**HISTORIC PRESERVATION REVIEW BOARD  
STAFF REPORT AND RECOMMENDATION**

Landmark/District:	<b>Mount Pleasant Historic District</b>	(x) Consent
Address:	<b>1656-1658 Park Road NW</b>	
Meeting Date:	<b>April 25, 2019</b>	(x) Subdivision
Case Number:	<b>19-208</b>	(x) Alteration
		(x) Revised Permit/Concept

*Above: The houses' front yard prior to the recent paving/repaving.  
Below: The front yard "after."*

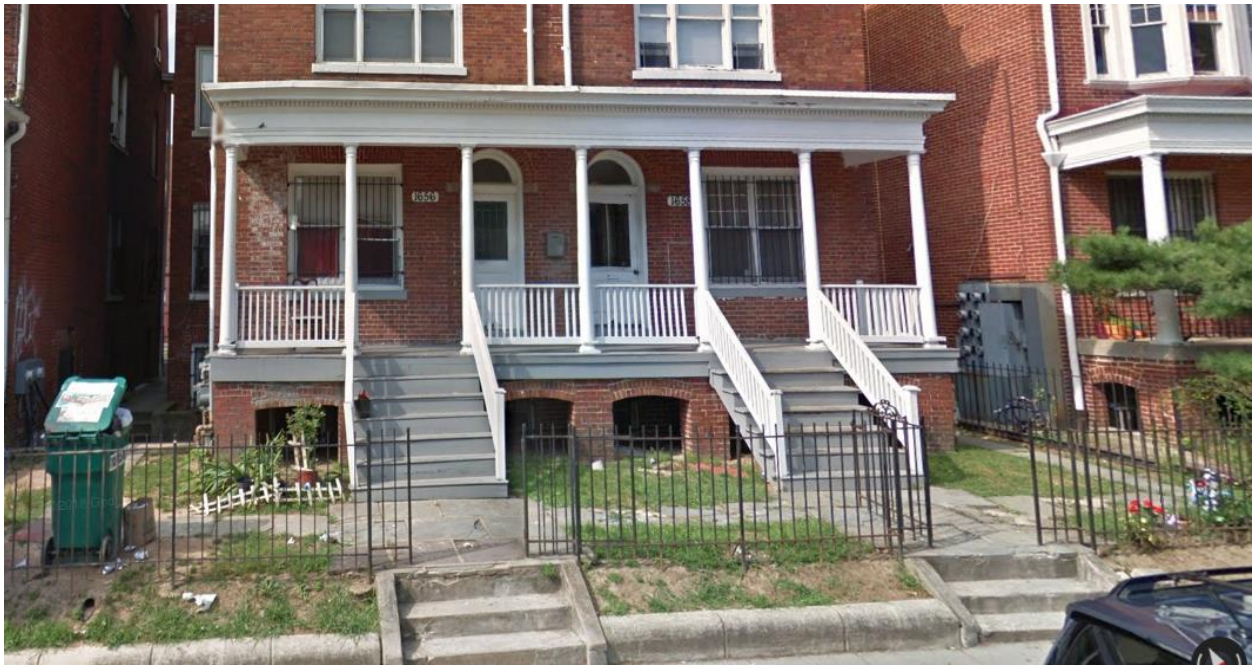
The other major item is the paving of the front yard. It had had straight-run concrete lead walks and steps, consistent with the rest of the row, bisecting grassed yards. The previous owners, rather than repairing or replacing the century-old walks, had stuck flagstones over them and had installed similar stepping stones as a walk around the buildings. The latter is consistent with the design guidelines, the former is not, in this instance. But now, nearly the entire surface of the yard has now been covered with flagstones, limiting the green areas to planters bounded by the paving and the curb at the public sidewalk (see photos, page 7). This requires a public-space permit and would not have been supported by HPO, because the Board's policy has long been to minimize front-yard paving, consistent with the published preservation design guidelines, the planning history of the District of Columbia, and recent comprehensive plans.<sup>3</sup> Staff is awaiting

a permit application to reduce the amount of paved area—and preferably to restore the concrete walks.

- 6. the restoration of true slate to the front roof—to match the color, cut, dimensions and coursing/exposure of the original slates—be carried out by May 28 or be subject to HPO enforcement action; and*
- 7. that the removal of the new paving from the front yard be carried out under a separate permit, to be cleared by HPO before or concurrent with the clearance of the subdivision and the addition permit.*
